<b>Standard Modification</b> Issue 2	Mod No. SM11906
		Page : <b>1</b> of 10
		Compiled : P Tunney
		Approved :

## TITLE : Stabilator Torque Tube Clamp

APPLICABILITY : **All Europa Variants**  
Mod Type : **New Build & Retro-fit**

**11906 - 01/06**

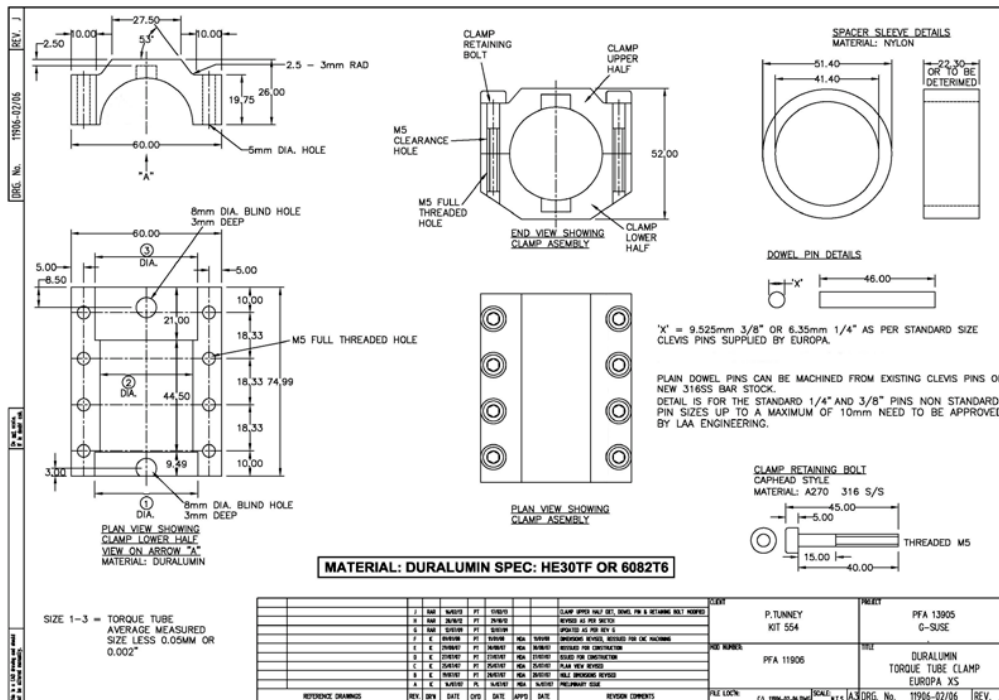
The clamp has been developed to prevent wear and looseness occurring between the 4 clevis dowel pins that secure the TP12 drive plates and TP9 crank arm to the torque tube TP4. See attached sketch (11906-01/06).

The reason for wear can be put down to either of the following –

- 1 – Minimal pin contact area (1/16") on the sleeves of TP9 and TP12.
- 2 – Poor initial installation from drilling through the sleeves of TP12 and plastic spacer sleeve TP10 that result in a larger hole or holes in TP12.

The clamp works by locking on all 3 major diameters of the components TP12, 9 and 4 and trapping shortened dowel pins in position. The clamps are machined to provide a 0.002" or 0.05mm interference fit on all 3 major diameters, and also to provide a neat fit between the ends of TP12 and TP9.
